5.0 ADMINISTRATIVE CONTROLS

OMAHA PUBLIC POWER DISTRICT  
 FORT CALHOUN STATION  
 UNIT No.1  
 Amendment No. 1, 2, 3, 4, 5, 6, 7, 8, 9, 10, 11, 12, 13, 14, 15, 16, 17, 18, 19, 20, 21, 22, 23, 24, 25, 26, 27, 28, 29, 30, 31, 32, 33, 34, 35, 36, 37, 38, 39, 40, 41, 42, 43, 44, 45, 46, 47, 48, 49, 50, 51, 52, 53, 54, 55, 56, 57, 58, 59, 60, 61, 62, 63, 64, 65, 66, 67, 68, 69, 70, 71, 72, 73, 74, 75, 76, 77, 78, 79, 80, 81, 82, 83, 84, 85, 86, 87, 88, 89, 90, 91, 92, 93, 94, 95, 96, 97, 98, 99, 100

FORT CALHOUN  
TECHNICAL  
SPECIFICATIONS  
Amendment No. A, 1A, 2B, 8B, 7B, 2A, 101

FIGURE  
5-2

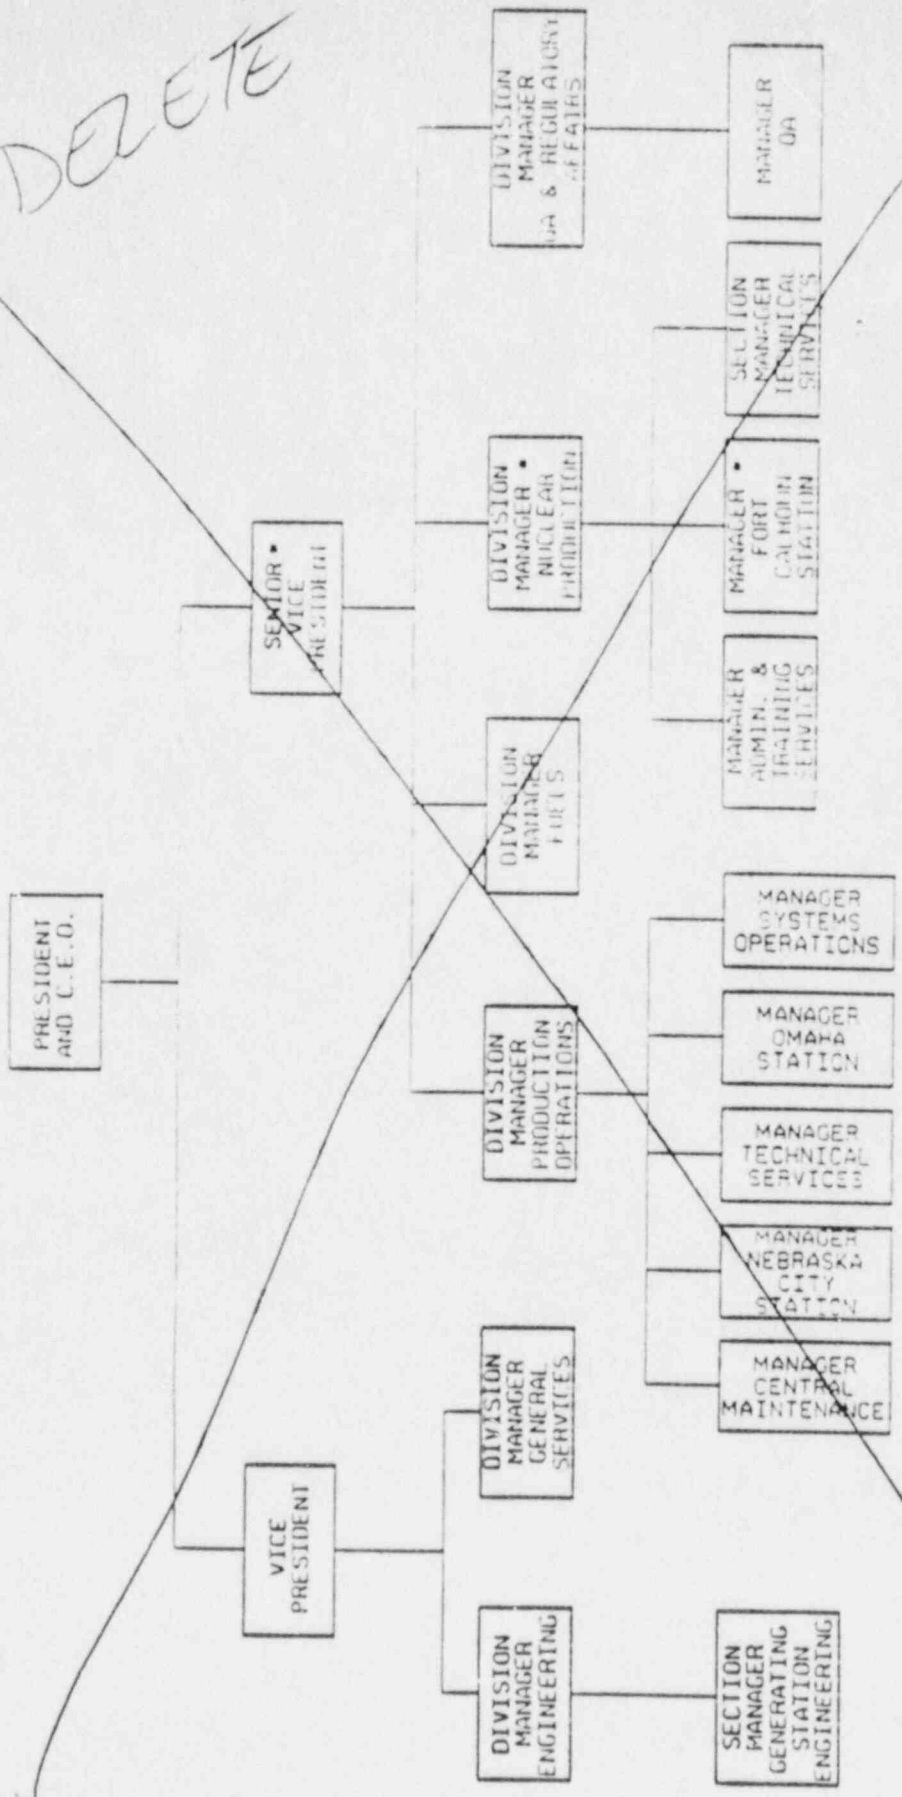
The plant staff organization shall be as shown in ~~Figure 5-2~~ and function as follows: described in Chapter 12 of the USAR

DELETE
